"AS-BUILT" - 10 SEPTEMBER 2004

Drawing Number: 038abad-Z1-3/1.1

PROJECT LOCATION, VICINITY MAP
AND DRAWING INDEX SHEET

SOUTH BRANCH BLACKLICK CREEK
ECOSYSTEM RESTORATION
WEBSTER MINE DISCHARGE
NANTY GLO, PENNSYLVANIA

CONTRACTOR WORK LIMITS
DIKE CREST RAMP

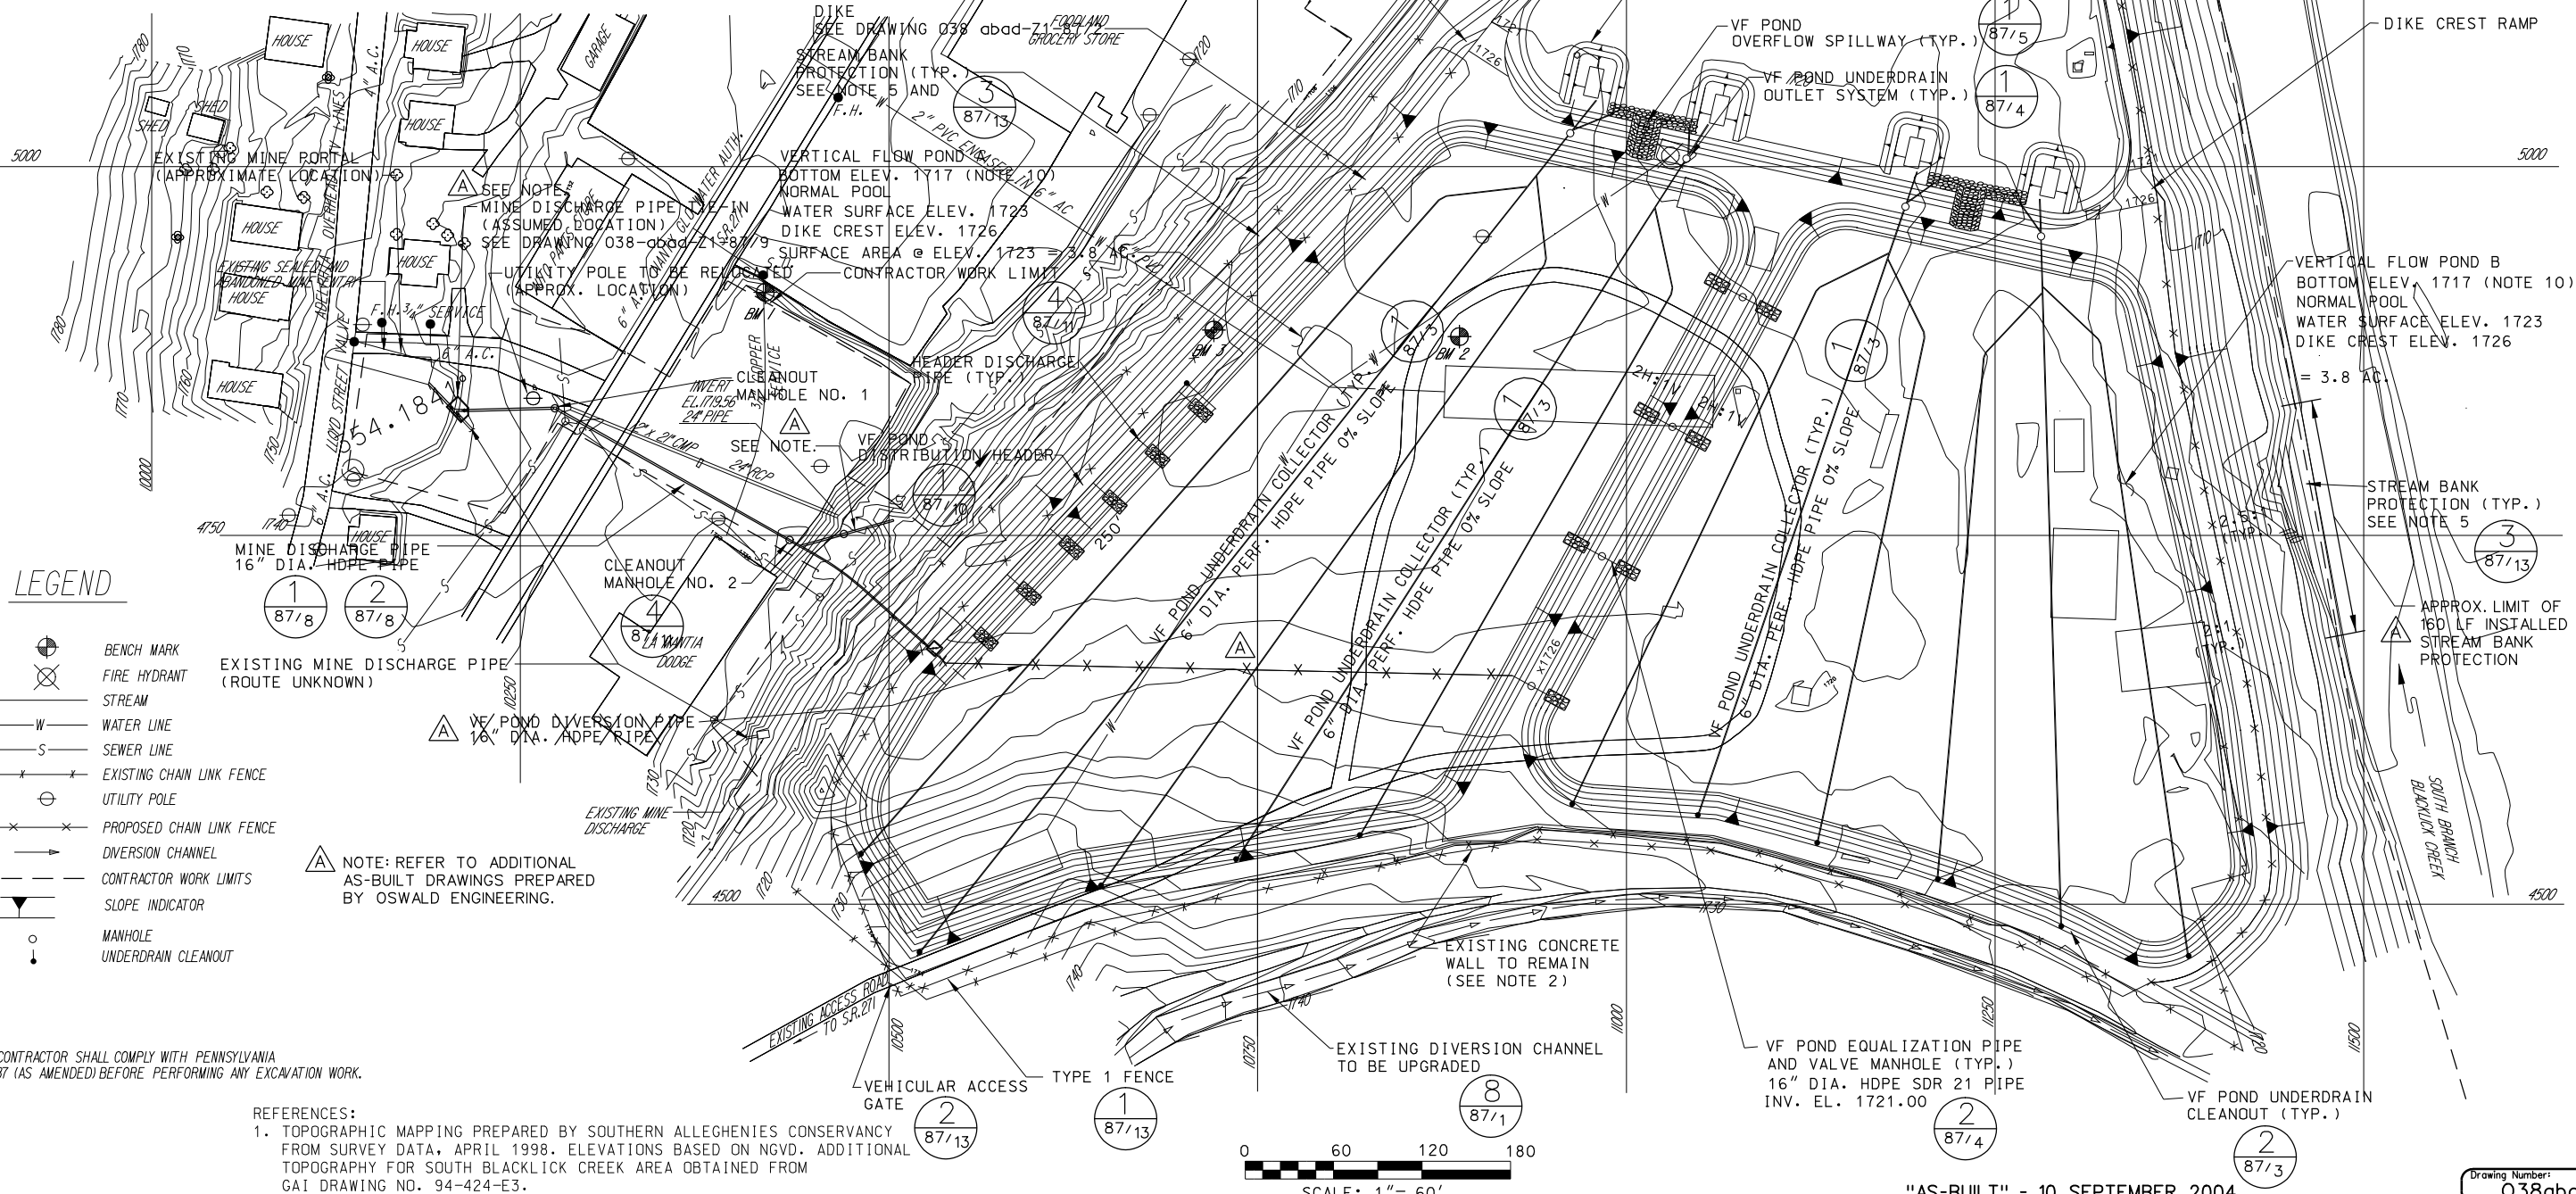
△ 160 LF OF STREAMBANK PROTECTION INSTALLED AT LOCATION SHOWN. ALL OTHER LOCATIONS WERE DELETED.

REVISION: REVISED "AS-BUILT" - STREAM PROTECTION

REVISION: REVISED, 16" HDPE PIPE DELETED & MANHOLE ADDED.

DEMOLITION PLAN

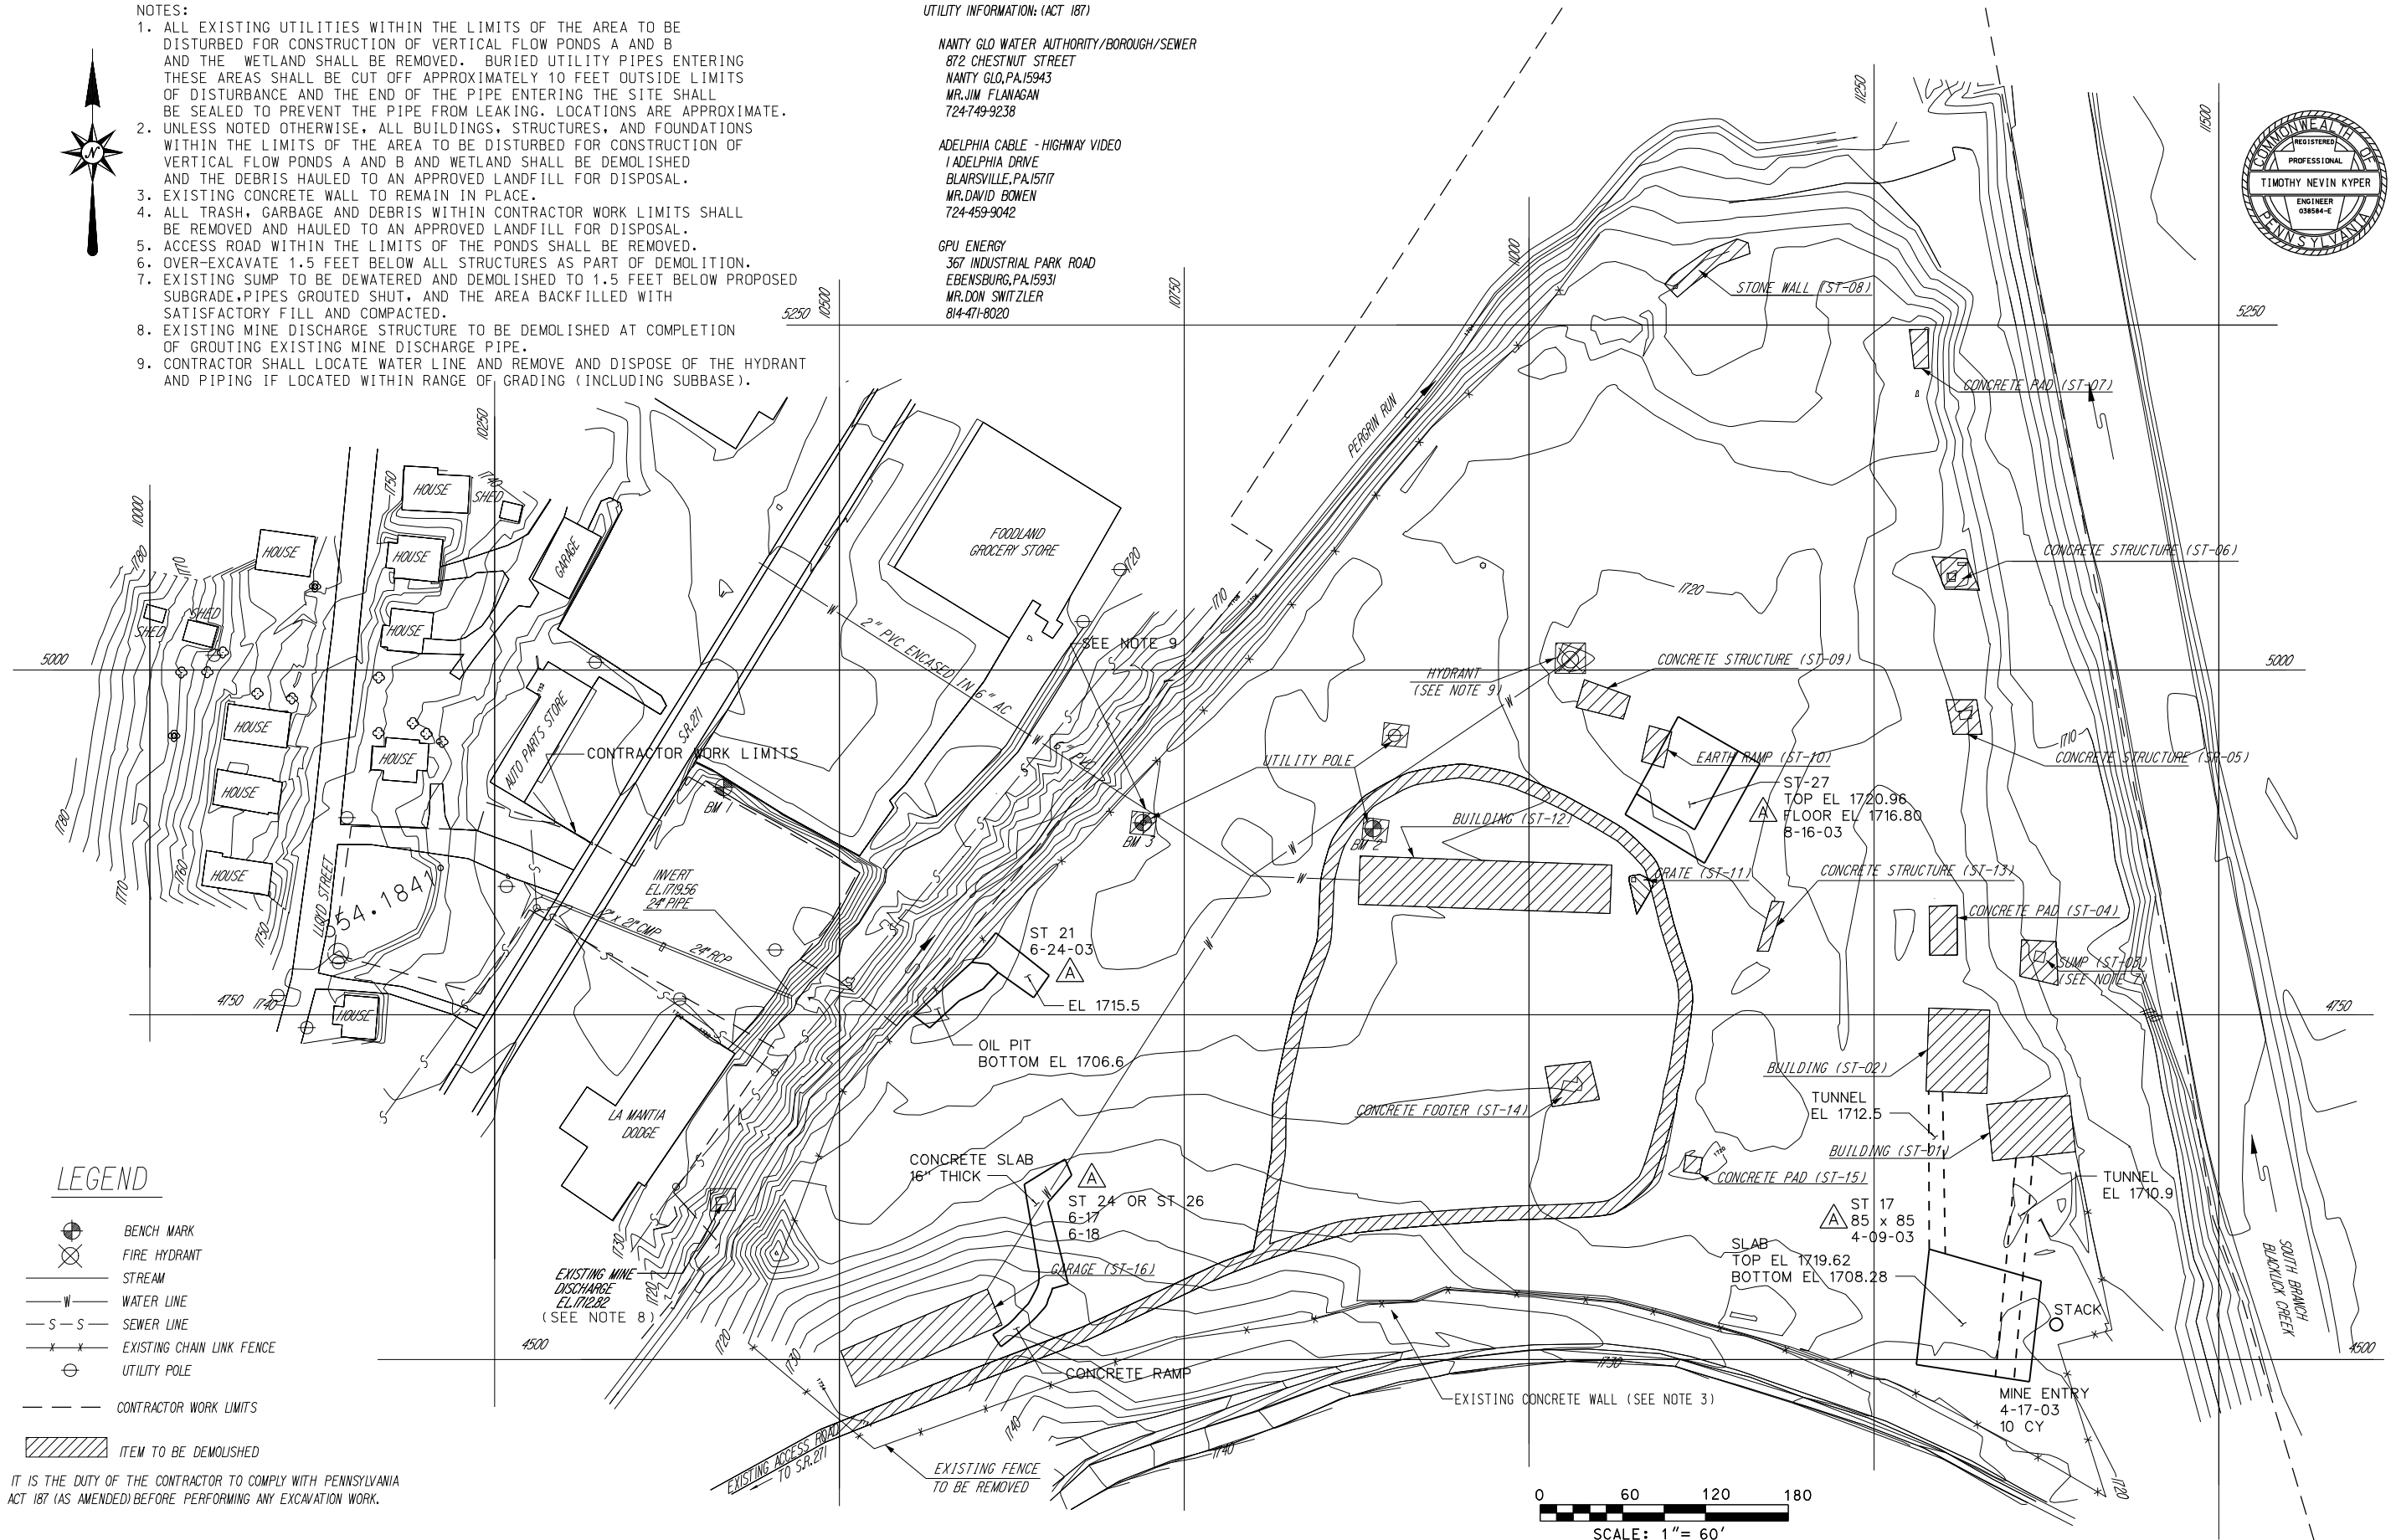
Rev.	Description	Date	Appr.
A	DRAWING REVISED "AS-BUILT" - ADDITIONAL STRUCTURES REMOVED.	7 MAR 05	LPB

PLAN
MINE DISCHARGE PIPE

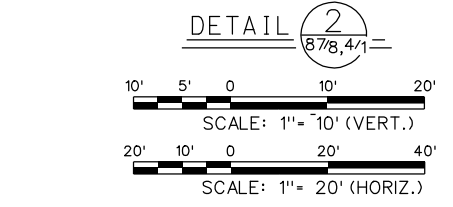
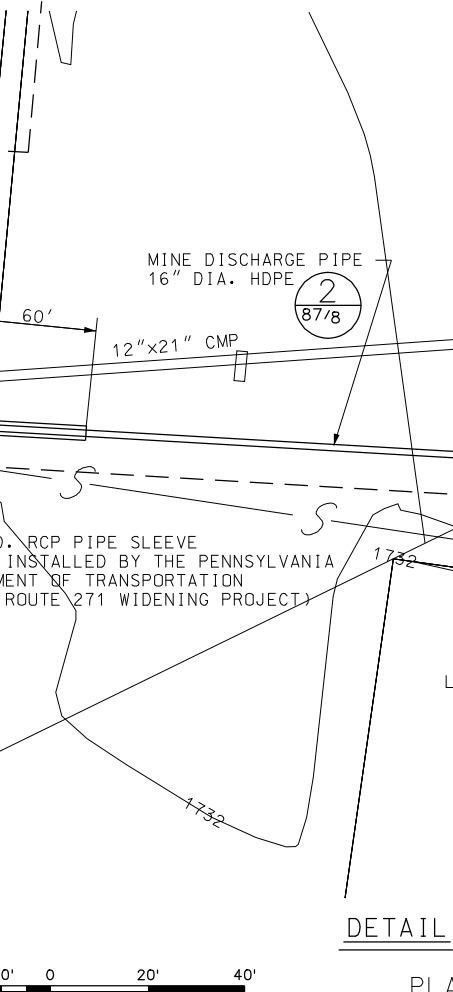
NOTE:
PIPE PLAN AND PROFILE WHICH WERE PREPARED BY GAI CONSULTANTS, INC. WERE REVISED ON 11 DECEMBER 2001 BY ADDING A 36" PIPE SLEEVE TO BE INSTALLED BY PADOT.
